**Application by Vattenfall Wind Power Limited for and Order granting Development Consent for the Proposed Thanet Extension Off Shore Wind Farm off the Coast of Kent
Request for Information and Comments on the Application: EN010084
Our Client: Ramac Holdings (Trading) Limited**

SUBMISSIONS IN RELATION TO THE ASSESSMENT OF ALTERNATIVES IN COMPULSORY ACQUISITION OF LAND – RESPONSE TO APPLICANT’S LETTER AND SUBMISSIONS DATED 13 DECEMBER 2019

Figure 1 – Extracted Figure 1.15

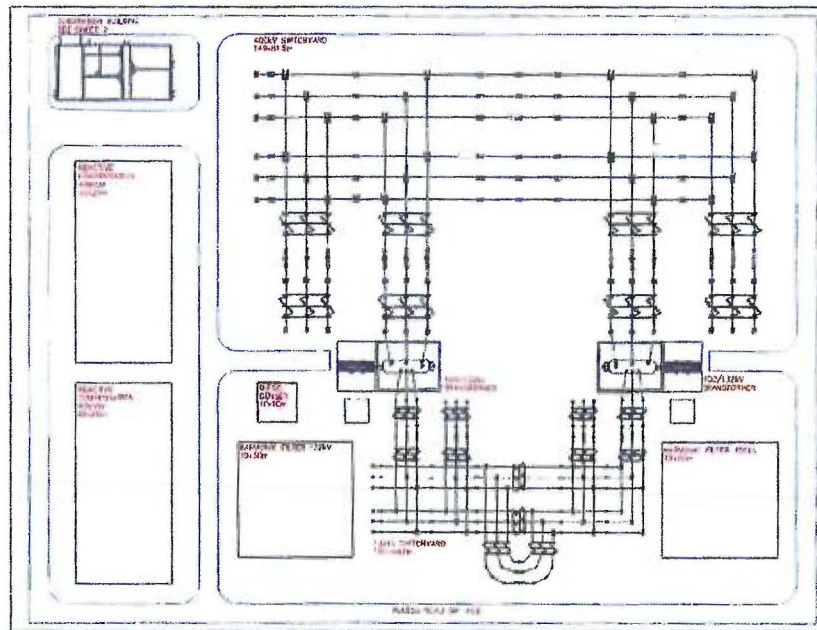
Vattenfall in their documentation have identified a substation area of 215m x 160m (c.8.6 acres) as advised in Table 1.3 of Volume 3, Chapter 1 of their Preliminary Environmental Information Report. Below, in figure 1, is an extract from the same document noted as Figure 1.15 and is titled as an "Indicative Layout of the Onshore Substation".

Also noted in the same documents are the components within the substation, shown in Section 1.5.74 and repeated in Table 1 below. Although not specifically noted in the above document, it has been later confirmed by Vattenfall that their substation scheme is based upon Air Insulated Switchgear (AIS) as opposed to Gas Insulated Switchgear (GIS).

Figure 2a – Multi Storey GIS Building Arrangement – Layout

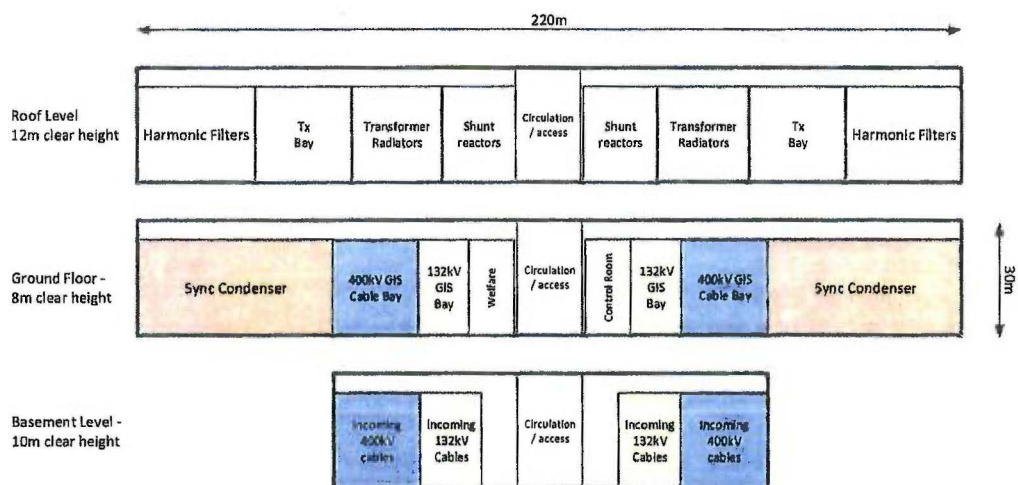
In Figures 2a and 2b below, are shown schematic arrangements of how the components noted in Table 2 might be arranged to reduce the footprint; note that all of the components that would have to have “outdoor” access to air and craneage are on the upper level, all other components are on the lower level including all the switchgear which is assumed to now be GIS.

The issue of why AIS has been assumed rather than GIS as a switchgear type has already been raised to Vattenfall through question and answer process to date. Vattenfall have responded that the difference is not sufficiently material to make a real difference. Whilst I would agree that there are other factors and equipment that can drive the sizing, the selection of switchgear is a key issue, not only in its own footprint but also as an enabler to allow a multi-storey arrangement as shown in Figures 2a and 2b.

Figure 4 – MOJ Replacement Land Substation Assessment

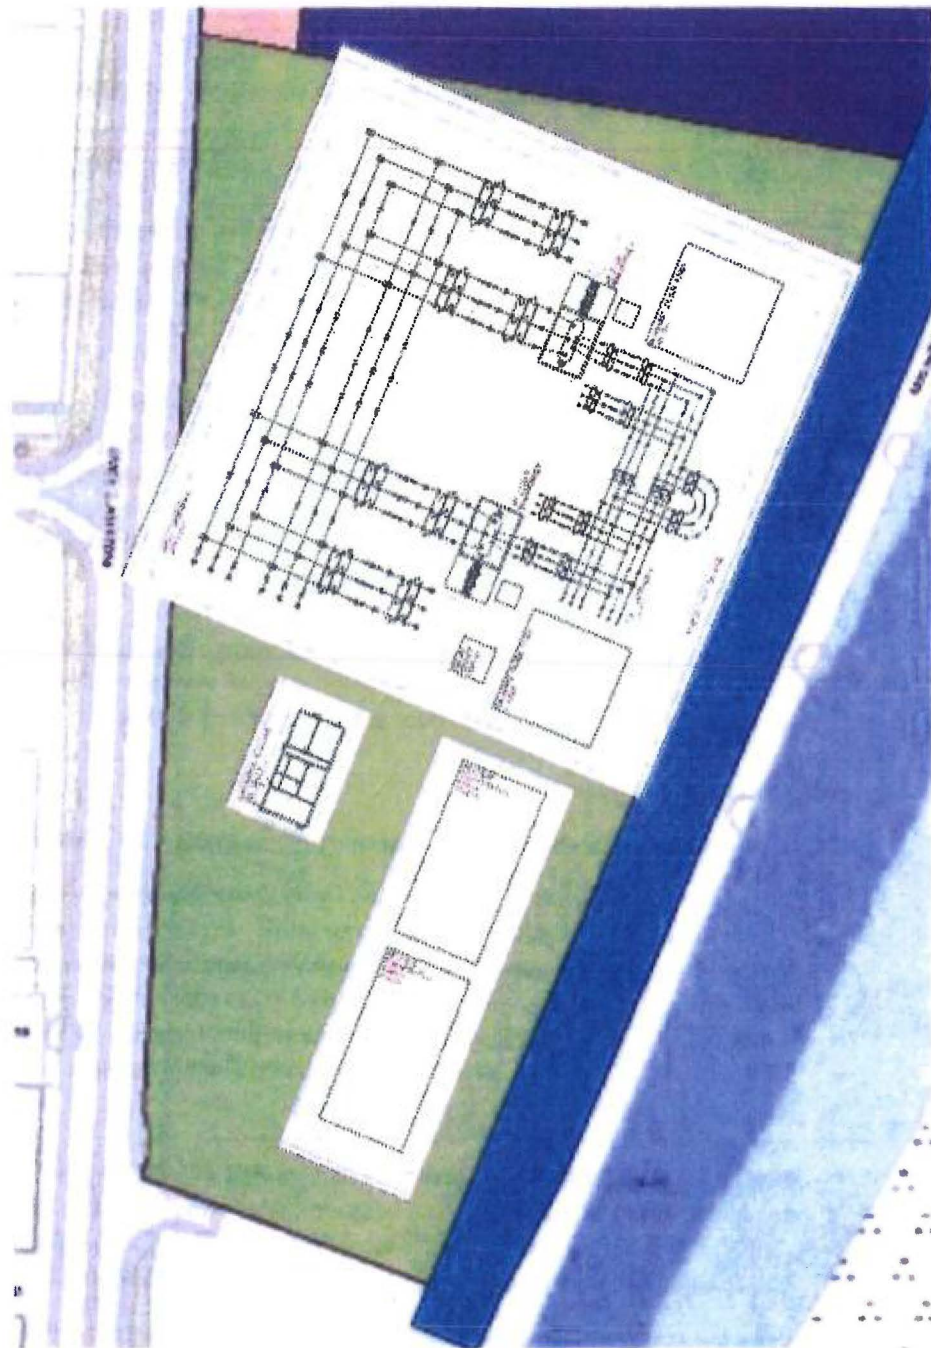
Using the land arrangement shown in Figure 3 above, an assessment has been made to see how the components of Vattenfall’s proposed AIS substation could be fitted within the site boundary. Figure 4 shows this assessment; it is fairly crude, but it does show that with some reasonable additional design input to the arrangement that the substation could be fitted

Figure 5 – MOJ Replacement Land - Alternative Substation Layout

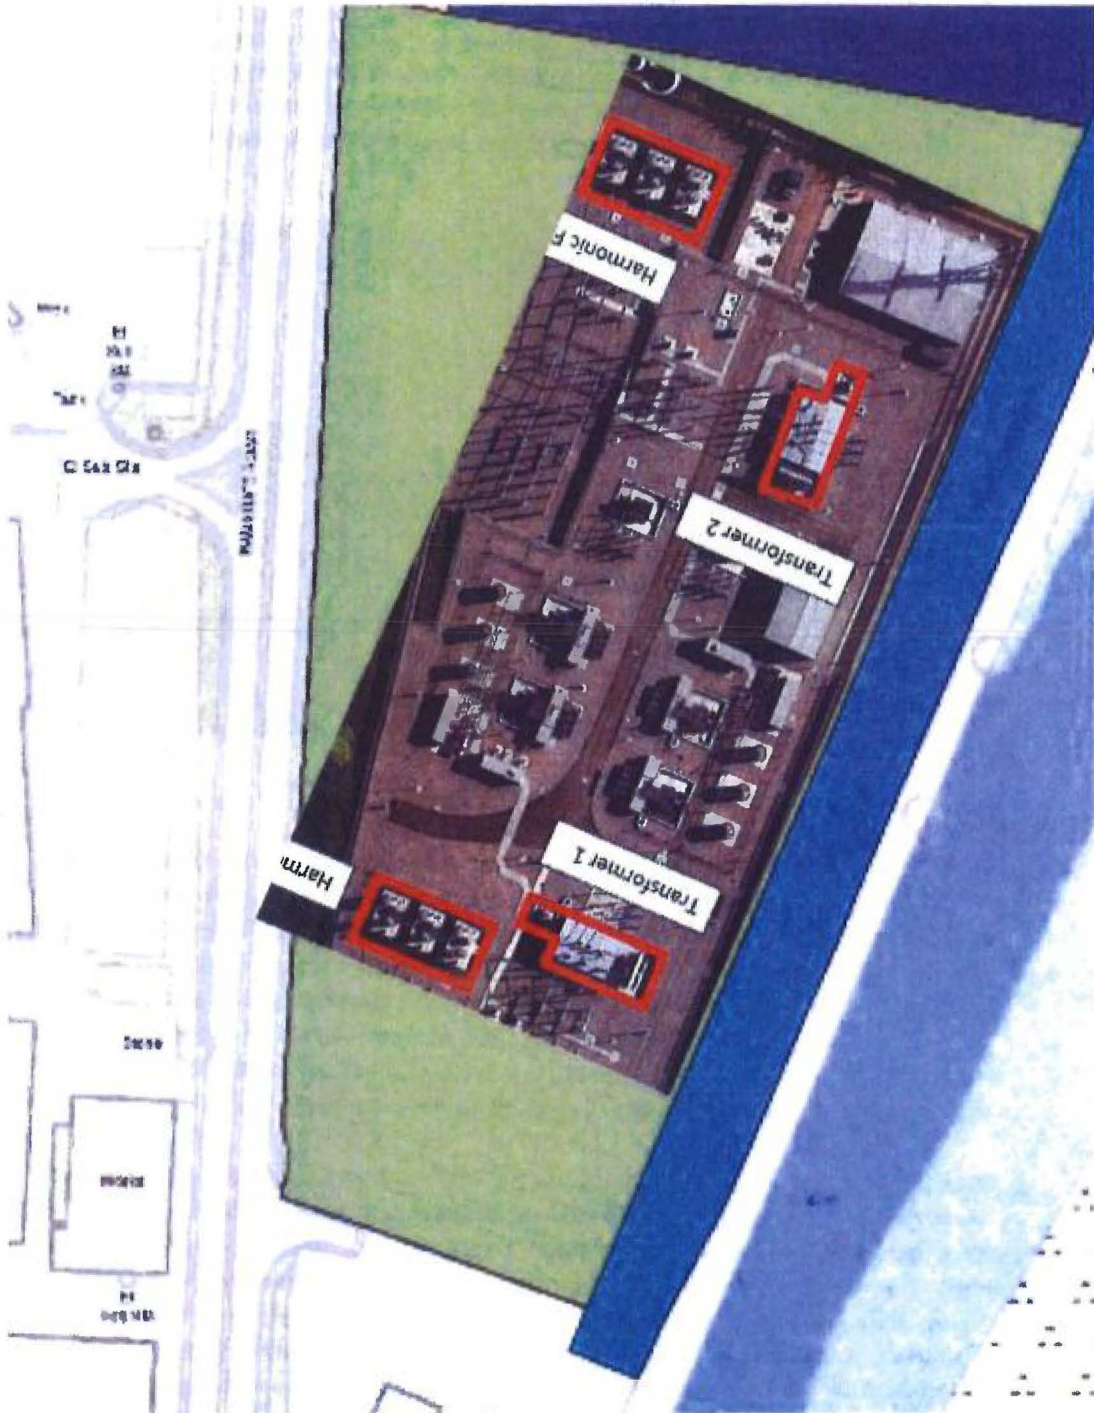
Vattenfall, in its latest submission in Annex B to Appendix 1 to Deadline 5, have in Section 2.3, Figure 1, including an example Onshore Windfarm Substation Layout. This is very useful, firstly because it demonstrates that other less square arrangements are possible, secondly because the area required appears to be reduced.

We have taken this Google Earth image and re-scaled it and applied it to the MOD replacement land, as shown in Figure 5. We have estimated that the area taken is circa 120m x 250m giving an overall area footprint of 30,000sq.m or 7.5 acres, so around 12% smaller than the footprint that Vattenfall are currently claiming. However what is as important, as shown in Figure 5 is that it fits very well with the MOD replacement land; the question arises as to why this hasn't been considered by Vattenfall?

Figure 6 – Stonar Cottage

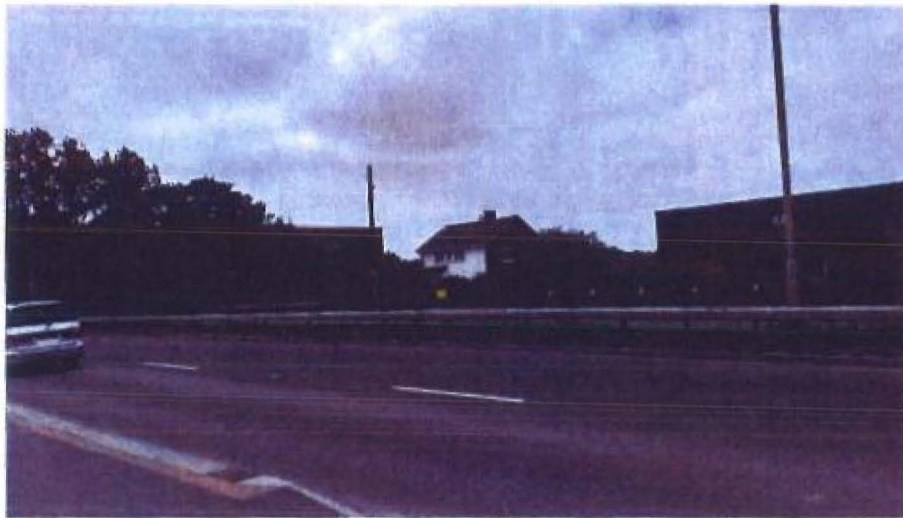
The nearest residence to the above site is Stonar Cottage, see photo below in Figure 6, which is estimated to be around 320m. Using the assessment process noted above, it is estimated that there would be an attenuation level of circa 42dB, therefore the reduction of noise emitted by plant will be $70\text{dB} - 42\text{dB} < 30\text{dB}$ and therefore be likely acceptable to the local authority. In any event, it would be possible to install attenuating elements to reduce noise and ensure that the chosen equipment keeps noise emissions to an acceptable level.

Figure 9 – Indicative trench arrangements for Sandwich Road
(extract from Volume 3, Chapter 1, Figure 1.14)

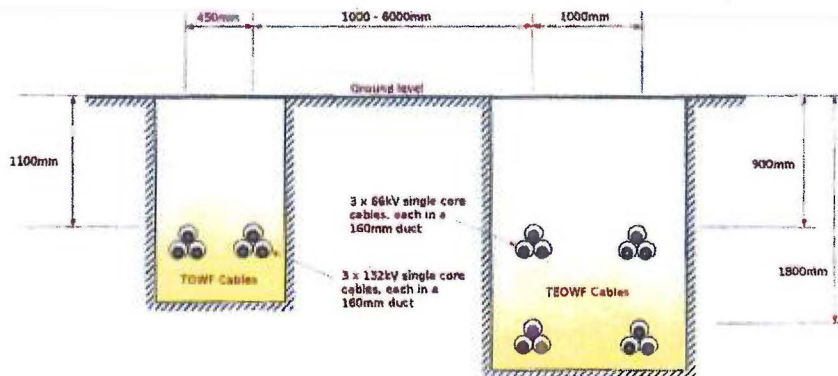
Vattenfall have advised that they have not yet decided as to whether the circuits from the offshore windfarm will be at 66kV or 132kV (the maximum voltage available to Vattenfall). Vattenfall have therefore shown two indicative versions of cable trenching for these two voltages as shown in Figure 9. The arrangements shown are typically for a DNO or IDNO distributing cables at these voltages. What is not defined are the limitations that will be applied to the land that they cross, such as the Bay Point Sports Club area; the norm is to run along public roads or footpaths. The limitations stem from (understandably) not interfering with the cables and the ability to access the cables should a fault arise. As such, no building structures, piling, concrete slabs should be built above these trenches as these will impede access. However, laying down of roads, car parks, gardens or walkways would be possible as these would still allow access.
